**PROJECT: FURNITURE FOR MAIN OFFICE AND BRANCHES****QUERIES/CLARIFICATIONS RAISED DURING THE PRE-BID CONFERENCE:**

## Non Supervisor Workstation (Non Client-Oriented)

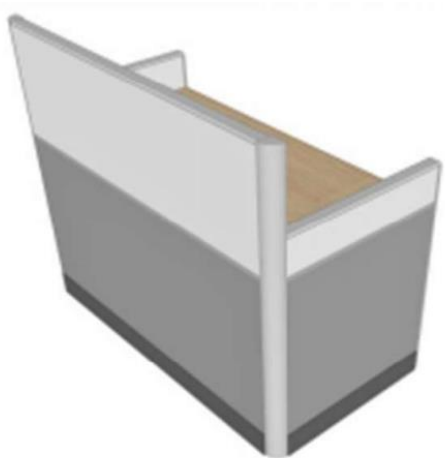
| 16 | Regarding the Lot 4 sample picture, what picture is the correct one to follow? There are two pictures presented in the documents.     | The picture with low partition in front will be used for workstations with transacting clients. The picture with high partition in front will be used for workstations with non-transacting clients. |

|   | Query/Clarifications   | TWG/BAC Reply  |
|---|--|--|
| 1 | Item #3 – Non-Supervisor’s Workstation<br><br>Which design do we need to follow? Because it will affect on the cost of materials. Is it specified in the Bill of Quantities? | The picture with low partition in front will be used for workstations with transacting clients. The picture with high partition in front will be used for workstations with non-transacting clients. |
